**SHEARON HARRIS NUCLEAR POWER PLANT, UNITS 2 AND 3
DOCKET NOS. 52-022 AND 52-023
SUPPLEMENT 3 TO RESPONSE TO USACE REQUEST FOR ADDITIONAL INFORMATION
REGARDING THE ENVIRONMENTAL REVIEW**

**Shearon Harris Nuclear Power Plant Units 2 and 3
Supplement 3 to Response to USACE Request for Additional Information Regarding the
Environmental Review, dated November 13, 2008**

NRC RAI #: USACE-15 (ER Subsection 9.3.2.2.1.5)

Attachment USACE-15A: Tech Memo Number 338884-TMEM-107, Revision 1, "Determination of Harris Reservoir Storage Requirements" [12 pages]

Figure 2
 Progress Energy Carolina
 Harris Advanced Reactor Units 2&3
 Lake Level Variation due to Different Makeup Pumping Rates from Cape Fear River

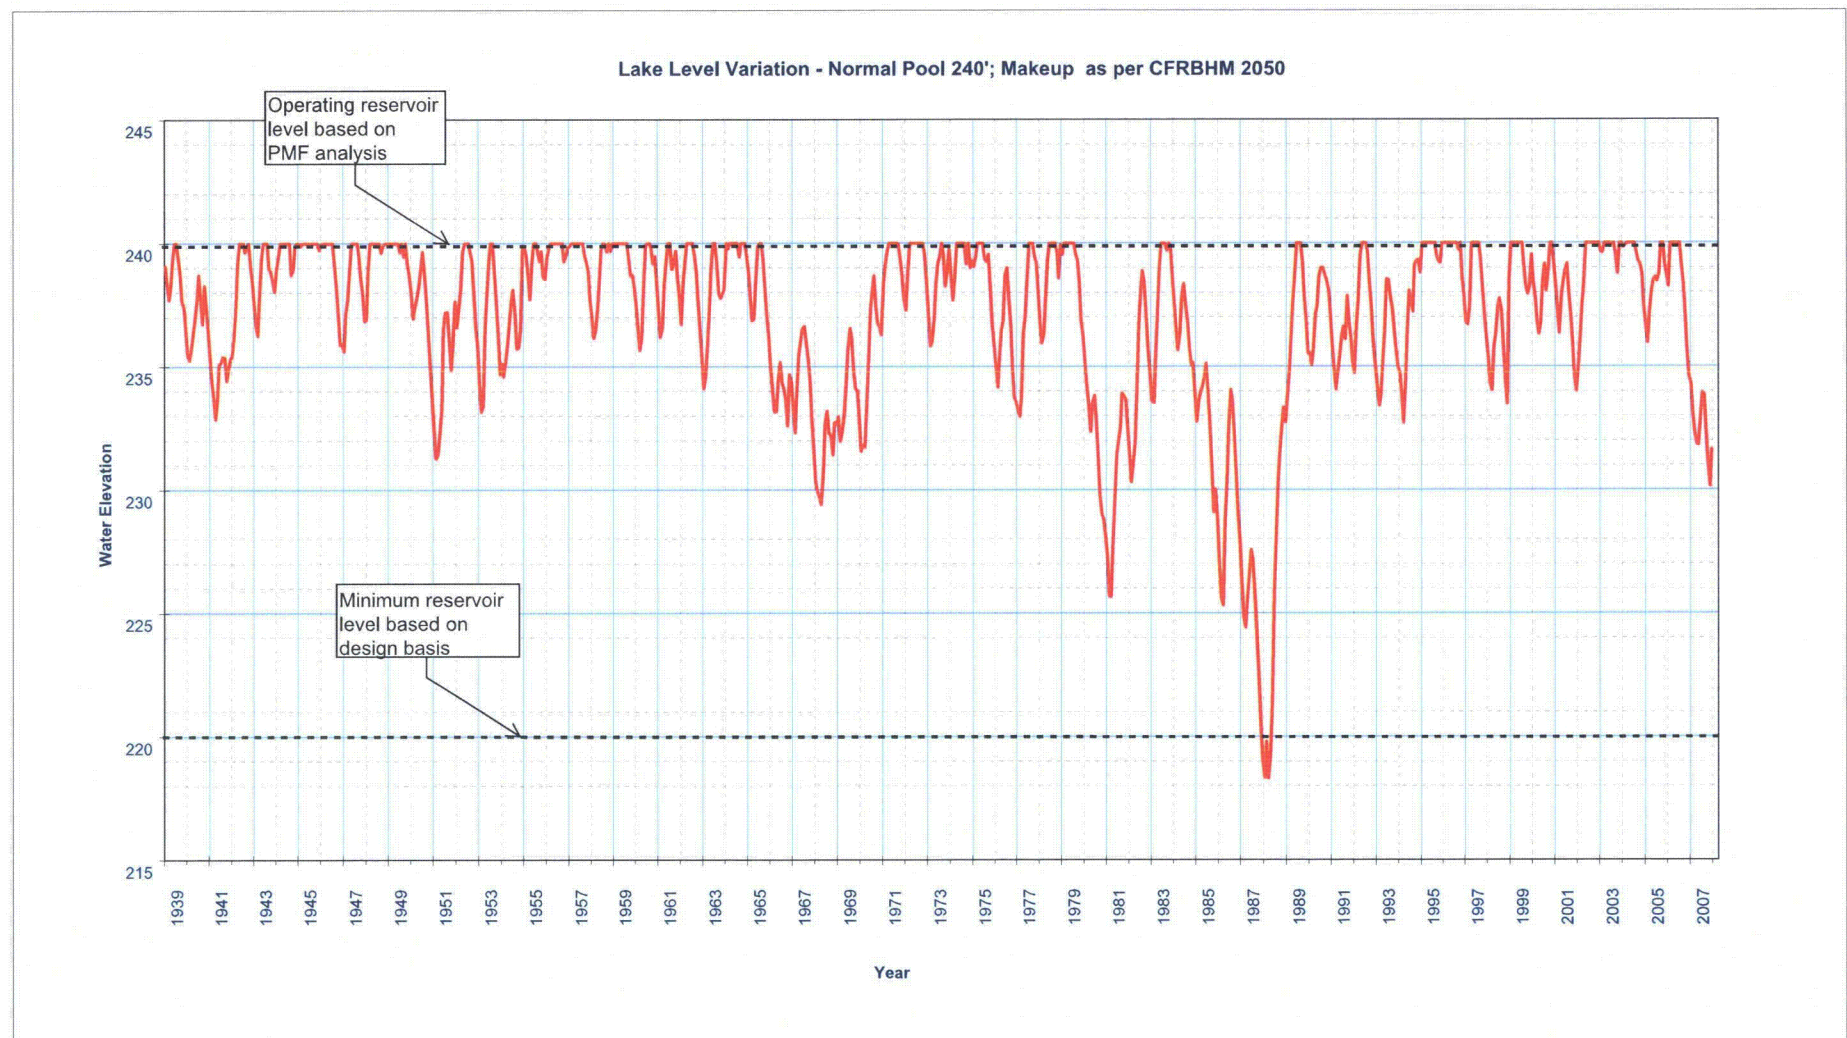
Please provide avoidance and minimization measures on impacts to streams and wetlands.

The results of these calculations are shown in Figure 2. Based on the historical inflows and meteorology, the most severe extended drought period was from 1985 through 1988. Figure 3 focuses on the reservoir level during the 1978 to 2008 period. This figure shows that a reservoir volume of at least 177,932 acre feet (ac-ft) (equivalent to a reservoir level of 240 feet) provides sufficient storage to maintain the reservoir level above the minimum design basis of 220 feet in all but the most extreme drought period. This would allow for continued operation of the three units during all but the most extreme events.
